**SUSQUEHANNA STEAM ELECTRIC STATION
EMERGENCY PLAN REVISION 59
PLA-7439**

**Docket Nos. 50-387
and 50-388**

List of Changes Contained in
Revision 59 to SSES Emergency Plan

Emergency Plan Changes Revision 58 to Revision 59

Susquehanna Steam Electric Station Units 1 and 2 Emergency Plan
EOF ORGANIZATION
FIGURE 6.4

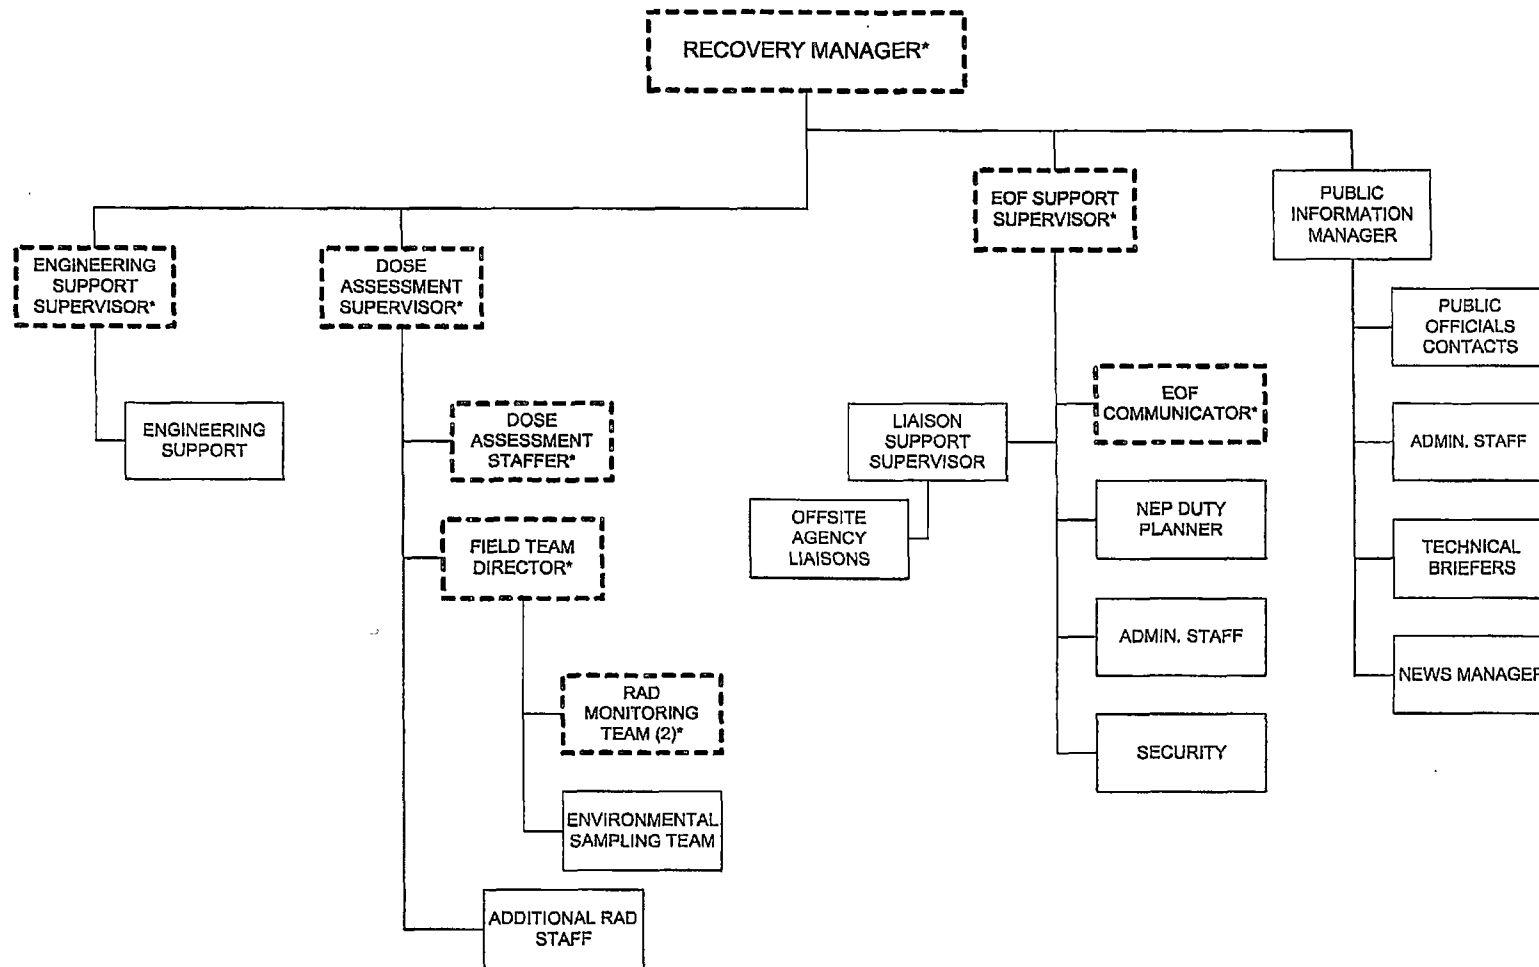
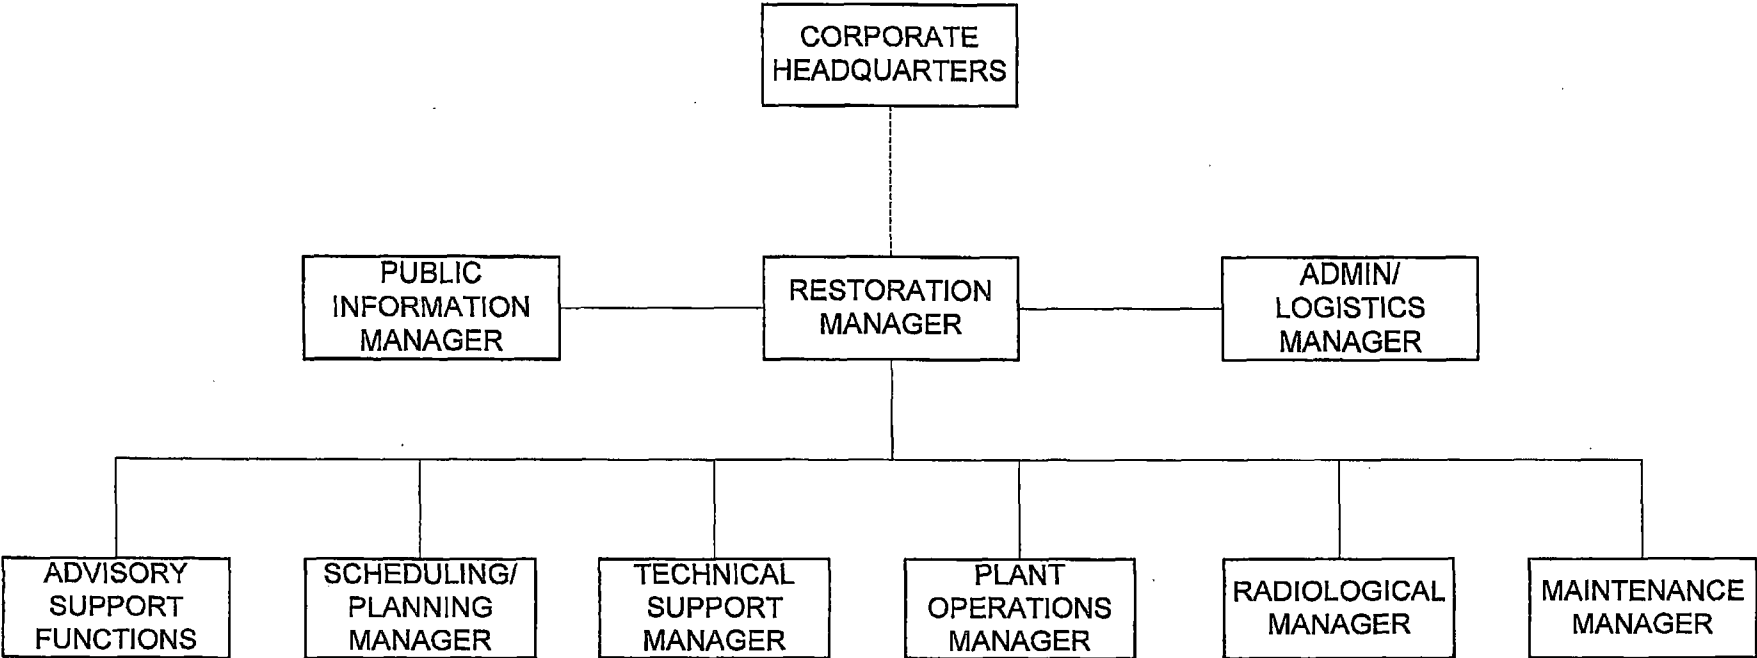
9. Corrected incorrect reference to Figure 6.3 in Table 6.1 to Figure 6.4 and changed the # footnote to state “2 are dispatched from the vicinity of the plant within 60 minutes” to match PLA-5589. (ACT-01-CR-2015-07468)

10. Corrected incorrect reference to Figure 6.3 in Table 6.1 to Figure 6.4 and changed the # footnote to state "2 are dispatched from the vicinity of the plant within 60 minutes "to match PLA-5589. (ACT-01-CR-2015-07468)
